W-3611 Hillcrest Property Development, LLC (McDonalds) (Special Use Rezoning from MU-S and HB-S to GB-S)

Project Name: W-3611 Hillcrest Property Development, LLC
(McDonalds) (Special Use Rezoning from MU-S and HB-S to GB-S)
Jurisdiction: City of Winston-Salem
ProjectID: 1226078

Thursday, March 7, 2024

FIGURE 6.1.3.E.2.B – CERTAIN CROSS ACCESS DRIVE REQUIREMENTS

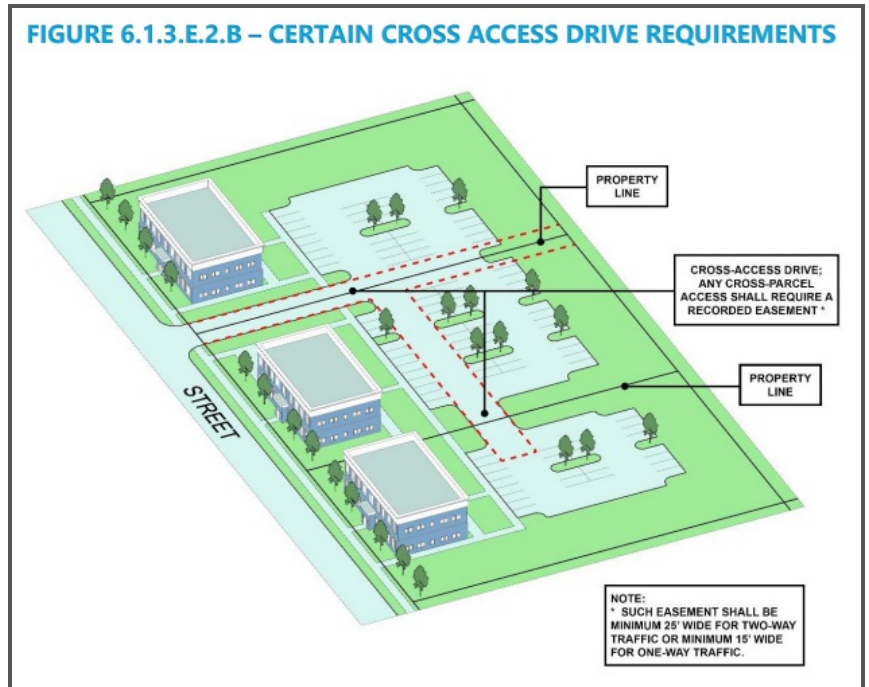
- **A 25' cross access connection to the northeastern parcel is required. You are showing this on your site plan. Please show the easement and the drive aisle extending all the way to the property line.**

FIGURE 6.1.3.G: SIDEWALK TREATMENTS

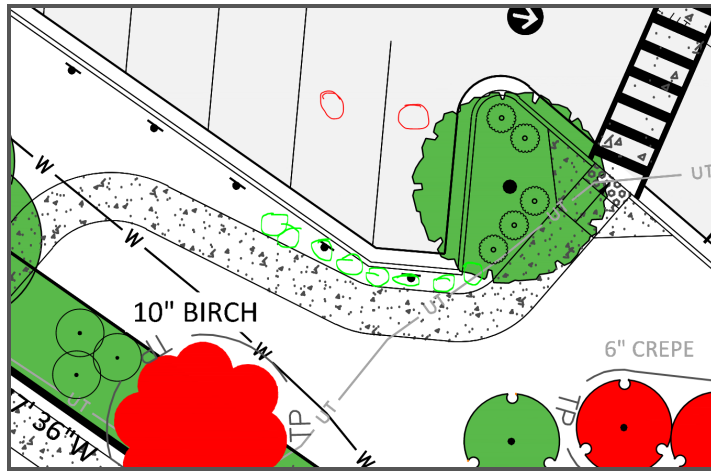
- Where parking abuts a sidewalk, one (1) of the sidewalk treatment options in Table 6.1.3G shall be met (see Figure 6.1.3G below).
 - **?The two spaces close to the pedestrian sidewalk meet the requirements for the 5' sidewalk with 2' planting strip or with a wheel stop.**
 - **Either provide a wheel stop that meets the requirements below or make sure something is planted in the "planting strips" below where parking spaces need treatment:**

- Pedestrian signage added to the plan.
- 90 degree parking spaces removed from plan
- This development has agreements in place that allows the cross access of all projects. There is no need to show site specific cross access easements. See BK 2755 PG 1869 & BK 2580 PG 1308 - Section 6 Parking & Access Easements
- Access drive updated to 25' wide
- Wheel stops added where parking is near the sidewalk.

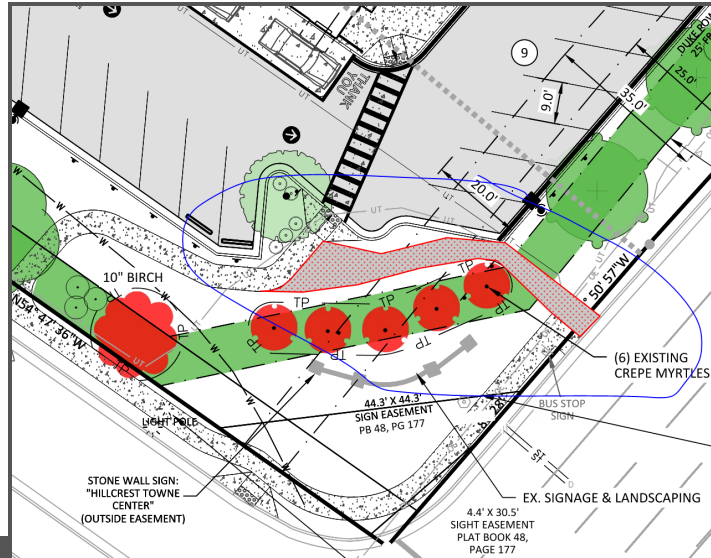
- The cross access connection will need to be built all the way to the northeastern property line, per the UDO 6.1.3.A.2.b.
- S. Stratford is a sidewalk designated major thoroughfare (boulevard) according to the CTP. As discussed in the Interdepartmental meeting, this will require an additional pedestrian connection to the sidewalk network, which at this stage, could function as a loop, like so:

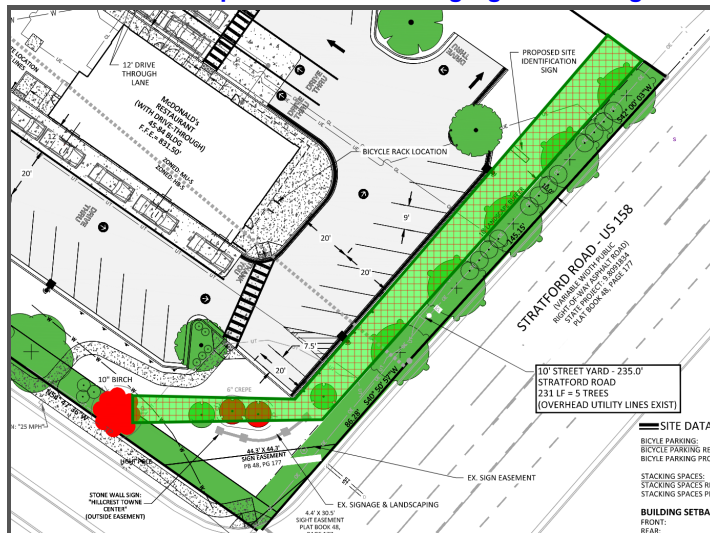
- Minimum streetyard width is ten (10) feet, and shall be measured perpendicular to the street right-of-way.?
- The streetyard shall be positioned between the motor vehicle surface area and street right-of-way.
 - ?To avoid the overhead utility line and ensure visibility of the complex's Hillcrest sign, planning staff recommends reorienting your streetyard in a variation of the following way, which would also create a better location near S. Stratford for the on-premises freestanding sign advertising McDonald's:

- 10 street yard added to Winterhaven Ln
- Front street yard adjusted as recommended.
- Additional landscaping added for compliance.

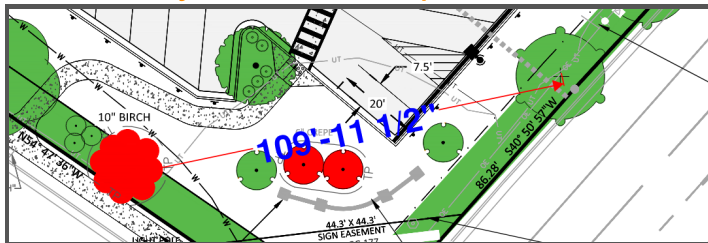
- **230' of frontage along the private access easement will require five (5) large variety trees.**
- Required trees must be a minimum of eight (8) feet in height at installation and shall be at least two (2) inches in diameter measured six (6) inches above ground level.

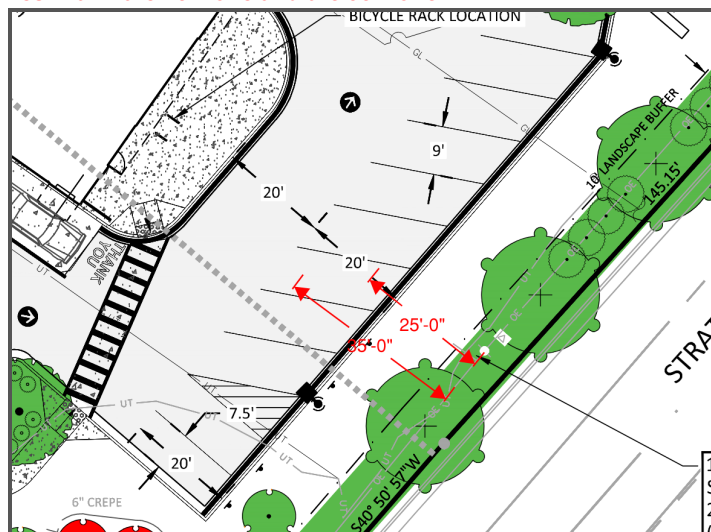
- Each planting area shall allocate a minimum of one hundred fifty (150) square feet per tree.
 - **?For each small or medium tree for the southeastern parking spaces, if needed, 150 SQFT of MVSA planting area outside of the Stretyard planting area is required (As discussed near the end of this comment, Stretyard planting area SQFT and MVSA planting area SQFT cannot double-count.**

- Each planting area shall allocate a minimum of six hundred (600) square feet for each large variety tree.
 - **?For six (6) large variety trees, 3,600 SQFT of planting area is required, with 600 SQFT for each large variety tree. After you designate your six (6) required MVSA trees, ensure that enough designated MVSA planting area is available for those MVSA designated trees.**

- Each planting area shall allocate a minimum radius of seven (7) feet for each small or medium variety tree.
 - **?MVSA-designated small or medium variety trees will need this planting area.**

- 6 trees shown in different color accounting for MVSA required plantings
- Overhead buffer zone calculations added

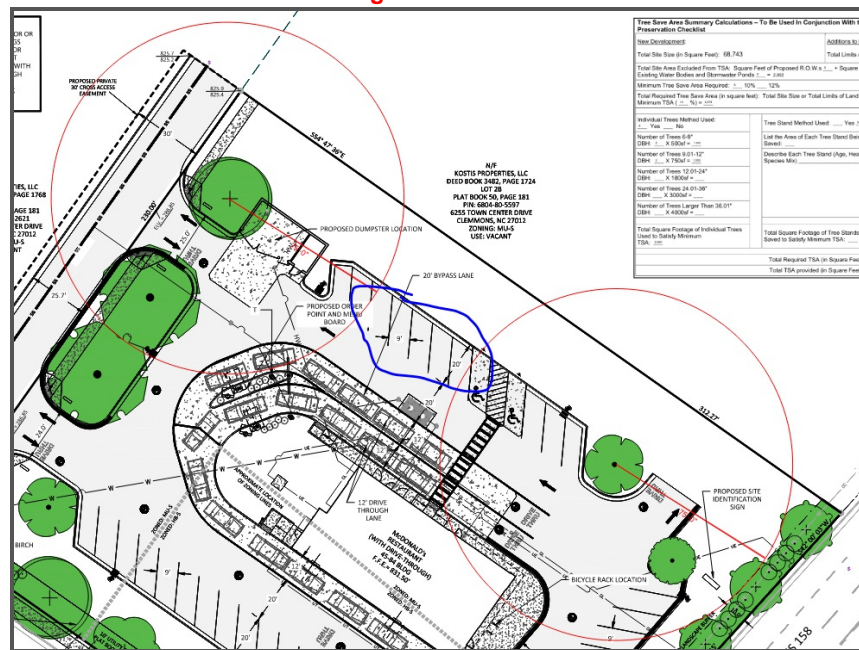
- No parking space shall be located more than seventy-five (75) feet from the trunk of a required large variety tree
 - **?Show the 75' radius measurements from your MVSA-designated trees to ensure tree coverage.**
- **Overhead Utility Lines:** Where overhead utility lines exist in accordance with Section 6.2.1B.10, Overhead Utility Lines, no parking space shall be located more than fifty (50) feet from the trunk of a required small or medium variety tree, unless otherwise authorized in this Ordinance.
 - **?The parking spaces located along S. Stratford Road is located within the Overhead Utility line bufferzones, and each one will need to be covered by a small or medium MVSA-designated tree's 50' radius.**

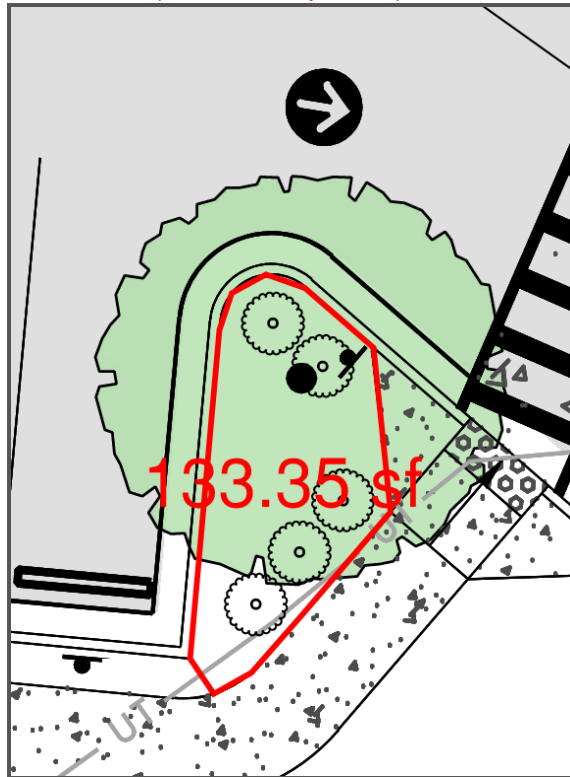
- The tree shown below cannot count as an MVSA tree, because it does not have either 150 SQFT (Small or Medium tree) or 600 SQFT (large variety tree) of planting area. **However, it does appear that other trees cover the necessary radius of parking coverage and have enough planting area.** All parking spaces are covered by different trees. **Label one additional tree (can be a streetyard tree) to count as the sixth MVSA tree.**

- One small variety tree with a minimum height of eight (8) feet at the time of installation and a minimum diameter of two (2) inches measured six (6) inches above ground level, and four (4) natural shrubs meeting the standards of Section 6.2.1D.2.d.i, Natural Shrubs, shall be required for every one hundred (100) square feet of planting area.
 - **Due to the above tree not counting towards MVSA requirements due to the amount of planting area provided, one of the small variety trees within the streetyard can count as a MVSA tree. This designated small variety tree will need 4 additional nearby shrubs.**

<p>Sambatek - Raleigh, NC Office Chris Nichols 9198486121 cnichols@sambatek.com 2/29/24 1:06 PM 01.03a) PC Review - 3</p>	<p>Revised plan showing one street yard tree as a MVSA tree and added 4 additional shrubs. Tree Save calculations adjusted accordingly.</p>
<p>City of Winston-Salem Nick Smith 336-747-7064 nicks@cityofws.org 2/29/24 2:49 PM 01.03a) PC Review - 3</p>	<p>Issue Closed</p>
